Project #19-001
Logan Gateway Office Building
Located at 701 South Main Street

Project Name: Logan Gateway Office Building
Proponent/Owner: Gary Blazzard / Rodney Ellis, Lucy Ellis, Southpoint Holdings
Project Address: 701 South Main Street
Request: Rezone / Design Review / Conditional Use Permit
Current Zoning: Mixed Use (MU)
Date of Hearing: Feb. 28, 2019
Type of Action: Legislative / Quasi-Judicial
Submitted By: Russ Holley, Senior Planner

Staff recommends that the Planning Commission recommend **approval** for a rezone from Mixed Use (MU) to Commercial (COM) and Mixed Residential Medium (MR-20); and **conditionally approve** a Design Review and Conditional Use Permit for Project #19-001 Logan Gateway Office Building, for a 68,000 SF office building. located at approximately 701 South Main Street, TIN# 02-063-0010; -0011; -0012; -0013; -0016.

SITE PLAN WITH PARCEL LINES

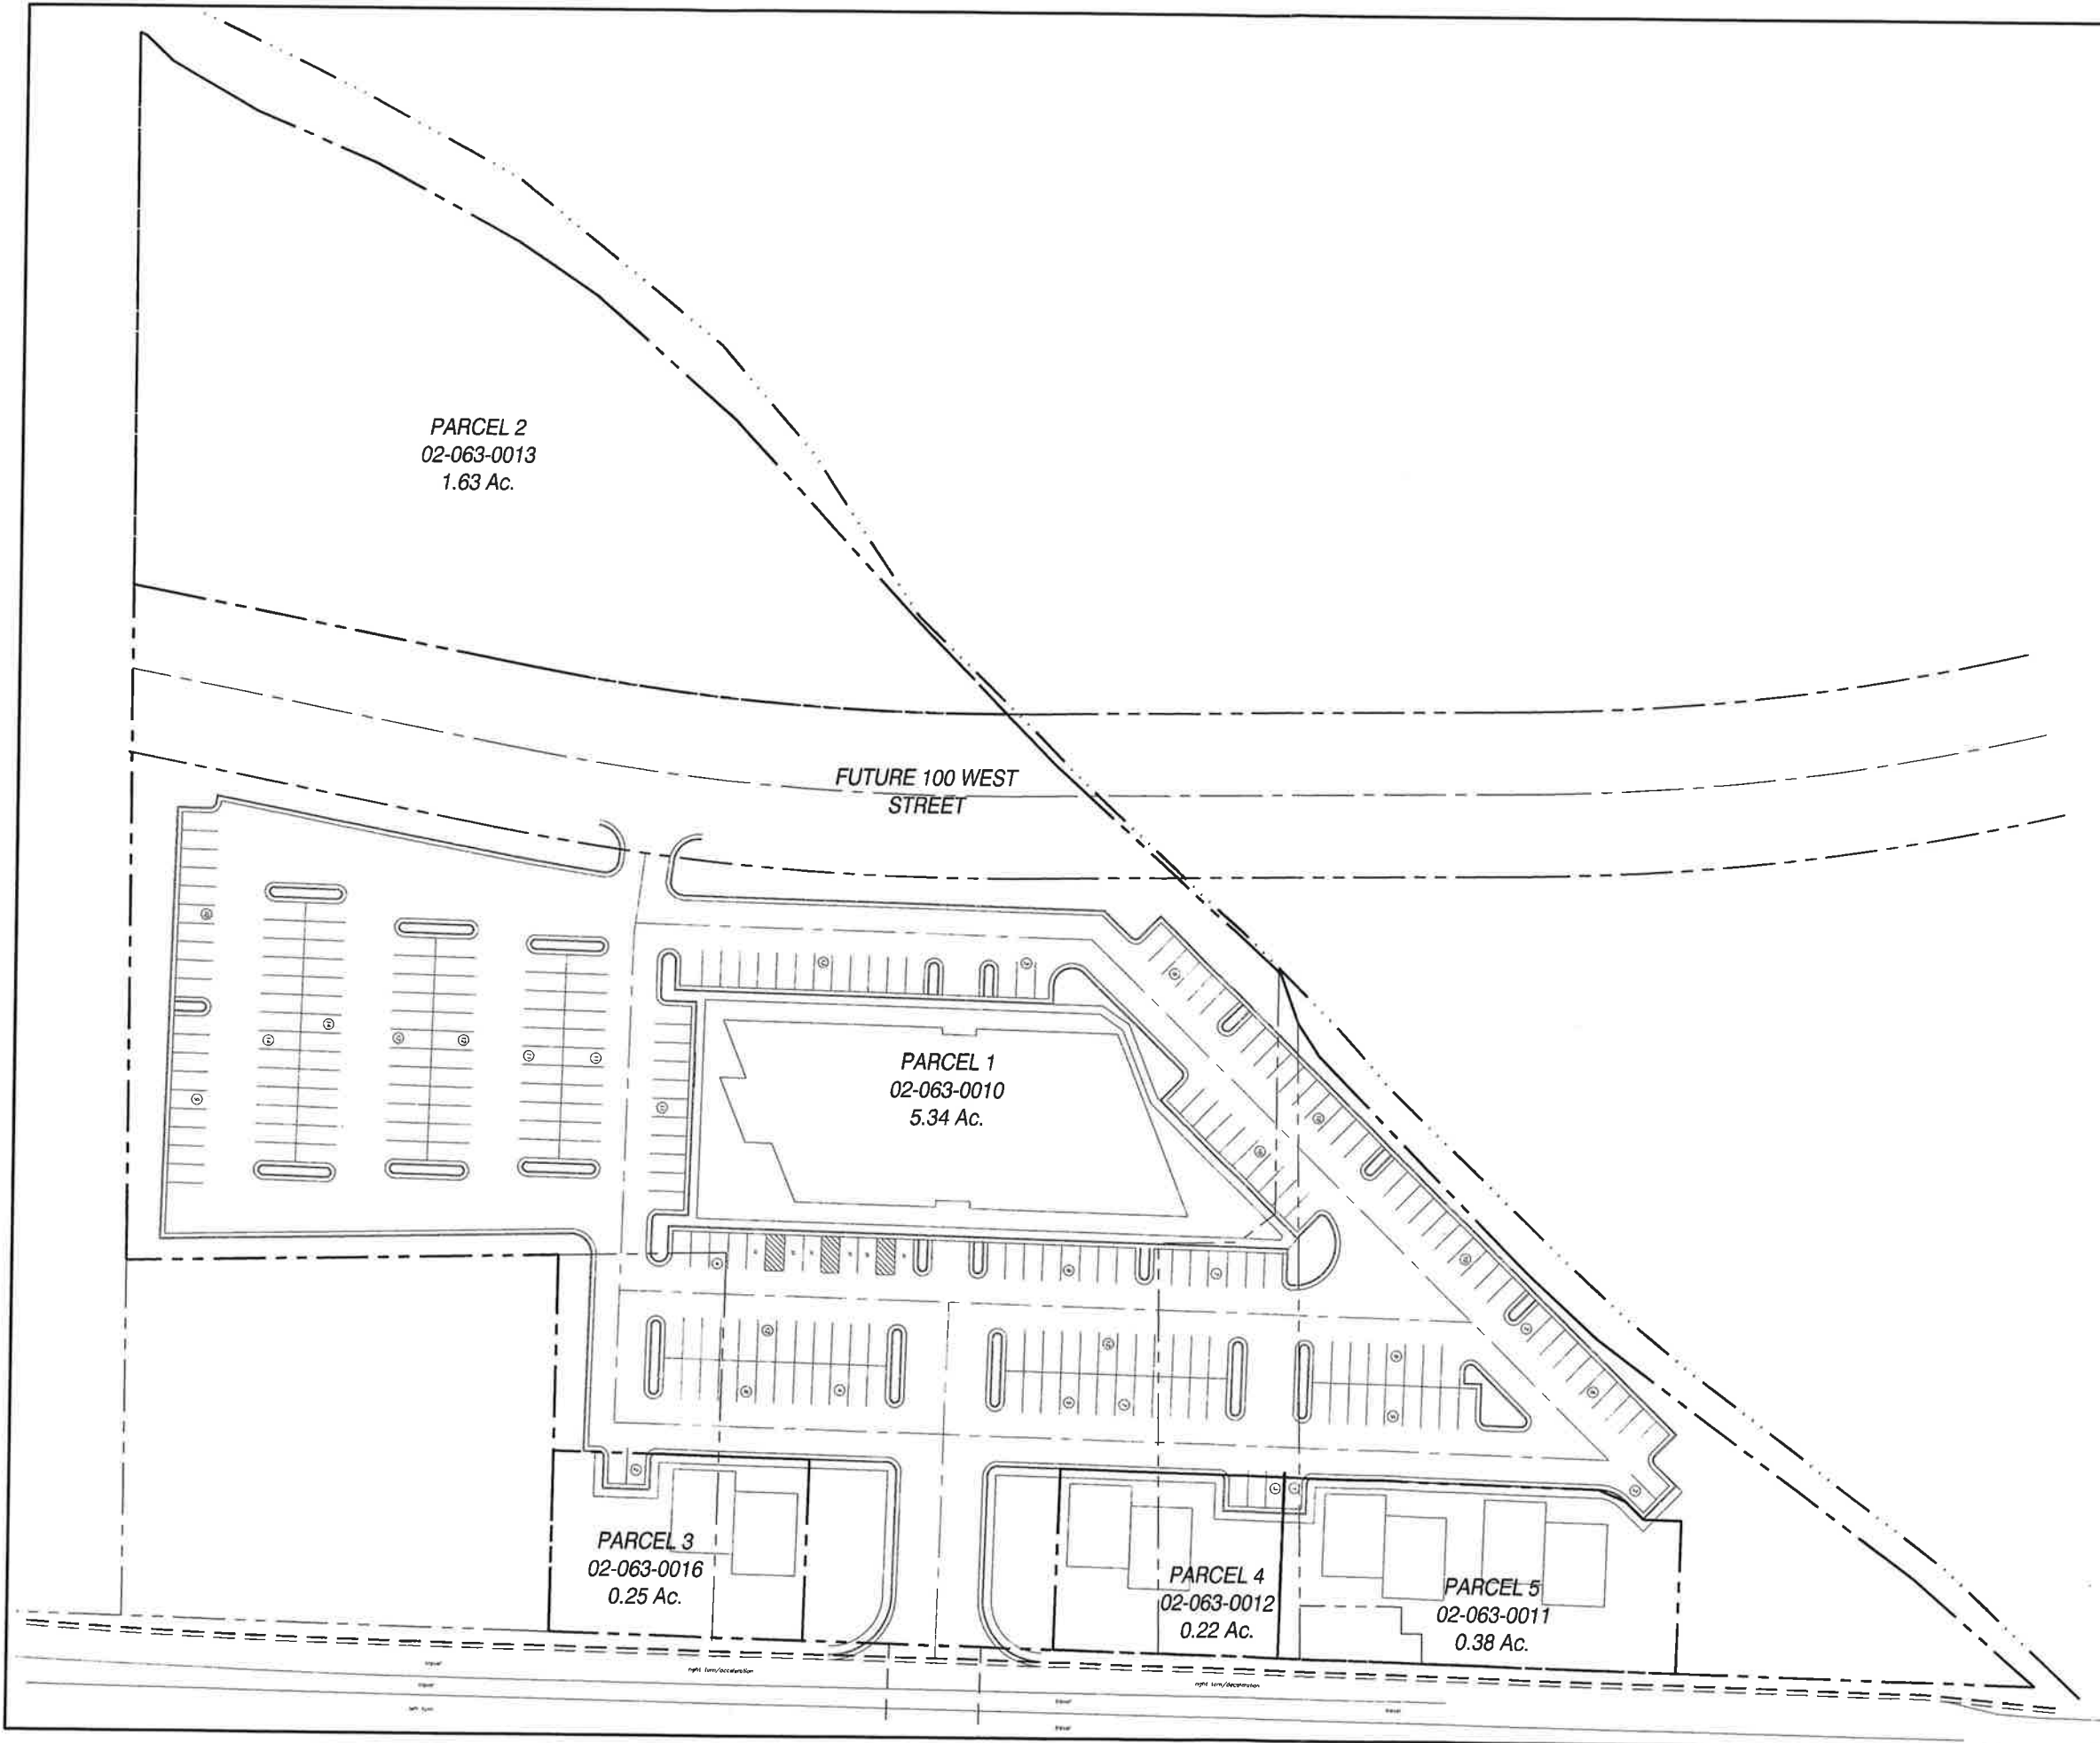
The LDC 17.10.080 typically requires parking areas to be located to the side and rear in the COM zone to prioritize architecture and curb-appeal over surface asphalt parking lots. In unique circumstances, the COM zone, through a Conditional Use Permit process, allows for a limited amount (50% max. req. parking) of parking area to be located within the front yard. Enhanced landscaping and pedestrian features are required as part of the Conditional Use Permit. Findings shall be made that show that the proposed development is compatible and consistent with surrounding businesses and development patterns. There are some front yard parking areas along the 100 West corridors in areas developed in decades past under different ordinances. Typically, the newer developments in the region, especially along south Main, have parking lots in the side and rear yards. As conditioned, the project meets the requirements of the LDC.

The LDC 17.31.040 requires one (1) parking stall per every 300 SF of office space. The proposed building(s) total approximately 65,000 SF of office space. This building configuration would require 216 parking stalls. The proposal includes 224 parking stalls. As proposed, the project meets the parking requirements in the LDC.

The max height of the main building, the equipment screen walls on top of the roof extending to 66' in height and the compatibility and consistency of the proposed front yard parking lot to the adjacent and adjoining business will warrant special consideration and findings from the Planning Commission. Staff continues to urge the Planning Commission to use careful consideration in project approvals for overall fair and consistent permitting.

4. The Planning Commission allows for front yard parking as proposed along 100 West because it is less than 50% of the total parking requirement and the surrounding properties and character of the area currently include some front-yard parking lots.

9. A trail easement is voluntarily provided that will allow the City to extend the trails network along the river corridor.
10. The project shall provide a minimum of 216 parking stalls for the proposed office building.

SHEET TITLE
EXTERIOR ELEVATIONS

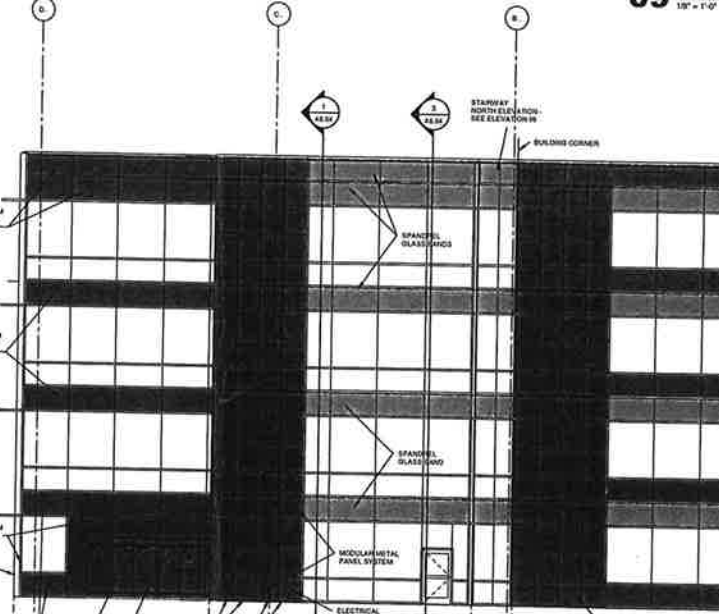
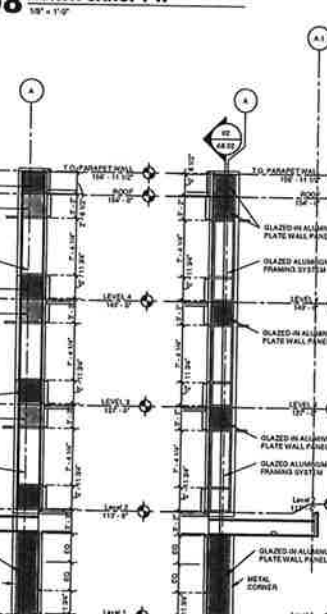
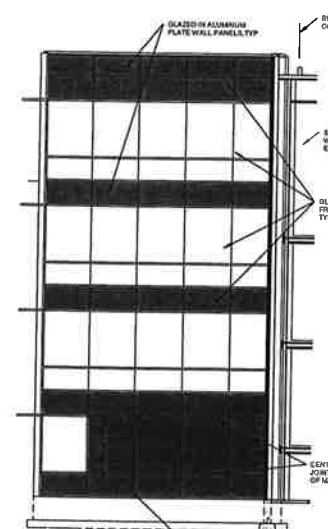
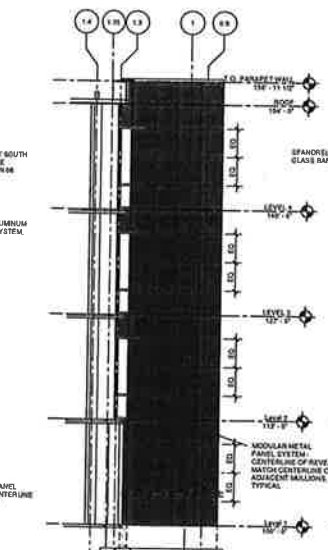
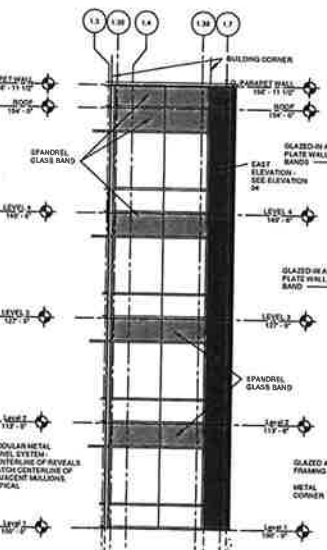
The proposed building is 56'-11.5" with some parapet areas reaching 66' tall. The upper parapet walls are intended to screen mechanical equipment that is placed on the roof and setback to the center area. The LDC allows limited non-habitable height exceptions, such as spires, domes, belfries, etc. on no more than ten percentage of the roof area and as approved by the Planning Commission. As conditioned with upper mechanical screen walls limited to 10% of the roof area, the project complies with the requirements in the LDC.

The LDC 17.12.020 states that commercial buildings should be designed to promote high-quality and aesthetically pleasing developments. The proposed office building shows glass, galvanized aluminum, modular metal and spandrel glass as building materials. All of these materials are permitted in the COM zoning district and the architectural design of the buildings meets minimum LDC building transparency, articulation, and all other general building design standards. The LDC requires buildings to be oriented towards the adjacent street with human-scaled features and entryways in prominent locations. Pedestrian entrances should have some form of weather protection provided above.

1. All standard conditions of approval will be recorded with the Design Review and are available in the Community Development Department.
2. The Planning Commission allows the main building height at 56'-11.5", as it is within the 10% discretionary adjustment allowance in LDC 17.43.080.

3. The equipment screen walls, considered by the Planning Commission to be "similar features" in the building area extensions as per LDC 17.12.050, may extend above the roofline but shall be limited to 10% of the roof area and positioned near the center of the building.
